URGENT FIELD SAFETY NOTICE

For all users of XO dental units XO 4 and XO FLEX

Fig 1. The typical placement of pacemaker and suction hose during treatment

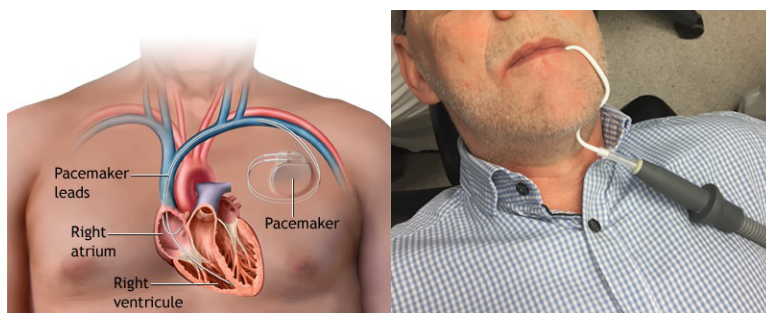
The suction hose on XO 4 and XO FLEX units is fitted with a magnet built into the dark grey nipple at the distal end of the suction hose, where it connects to the suction catheter. The function of the magnet is to control a contact that stops the suction action when the hose is placed in the cradle and automatically enable suction when the hose is lifted from the cradle. These nipples are sometimes placed on the patient's chest during treatment, in the immediate vicinity of any implanted pacemaker. (fig 1.)

XO CARE has been made aware of a single case, in which an implanted defibrillator made a warning tone in connection with positioning an XO suction hose immediately above an implanted defibrillator. By moving the suction hose from this position, the alert sound was discontinued.

The presence of the alert sound indicates that the defibrillator has sensed a magnetic field from the magnet in the suction hose, with a potential for impacting the functionality of the device as long as the magnetic field would remain in the immediate vicinity of the defibrillator.

XO CARE has designed a new suction solution which eliminates the use of magnets in the suction hoses. All new units produced since week 08-2018 are delivered with the new solution. At the same time XO CARE A/S has stopped producing hoses with magnets. Existing devices in the market will be updated as part of the preventive service program. Please contact your local service dealer if you don't have a preventive service agreement to secure the change.

- Be aware if your patient carries an implanted pacemaker or defibrillator
- Ask the patient about the pacemaker's position
- Ensure not to place the suction hose nipple in proximity of the implanted pacemaker
- If possible place a folded towel or similar over the location of the pacemaker such that the suction nipple is minimum 2,5 cm above the patient. Usage of a folded towel or similar will be sufficient.
- In general, you have to consider and treat the magnet in the suction hose equally to magnets and magnet fields you know from mobile phones and other household electronics.
- Pay attention if any acoustic signal occurs from the pacemaker, move the suction hose nipple immediately until the acoustic signal warning tone stops. Potential risk is hereby eliminated.
